APPENDIX 2
(CORRESPONDENCE WITH OBJECTOR)

PROPOSED PARKING RESTRICTIONS – BEECHWOOD ROAD / WITHAM AVENUE, EAGLESCLIFFE.

STOCKTON ON TEES BOROUGH COUNCIL (WITHAM AVENUE / BEECHWOOD ROAD, EAGLESCLIFFE, STOCKTON ON TEES) (24 HOUR WAITING RESTRICTIONS) (PROHIBITION OF WAITING) ORDER 2008

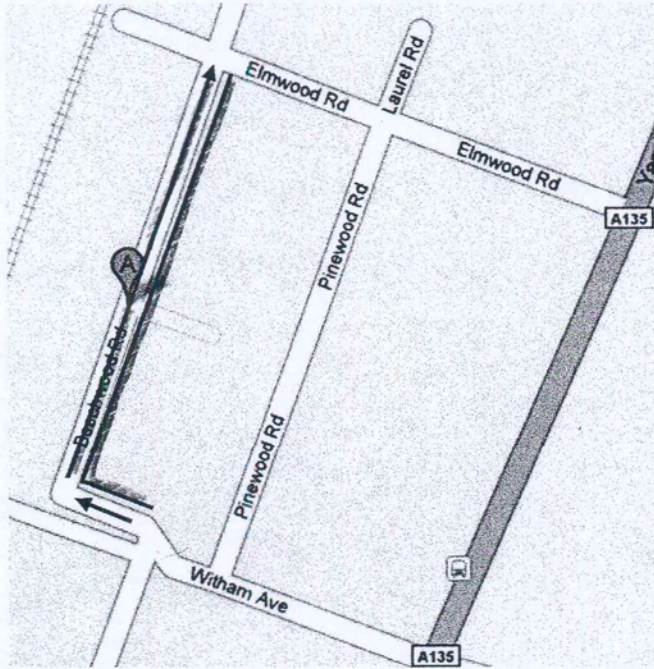
I feel that this proposal has no merit, the road has not changed and neither has the environment surrounding the area to warrant a change to creating a 24-hour waiting restriction in this area. However if the issue of safety is the main reason for proposing this change, I would recommend that the council consider making the debated area a one-way system and this would allow for parking, whilst also solving the issue of safety as no on coming vehicles would cause a problem. Below is a map with red arrows highlighting where I propose the one-way system to be put in place.

I note your request for a one way system. However, if a one way system was introduced it may result in increased vehicle speeds along Beechwood Road since drivers would be confident they would not meet, or need to give way, to oncoming traffic. It would also inconvenience residents in accessing their properties via a one way system as it may not be the most direct route. This could then lead to people contravening the one-way and result in enforcement issues for Cleveland Police.
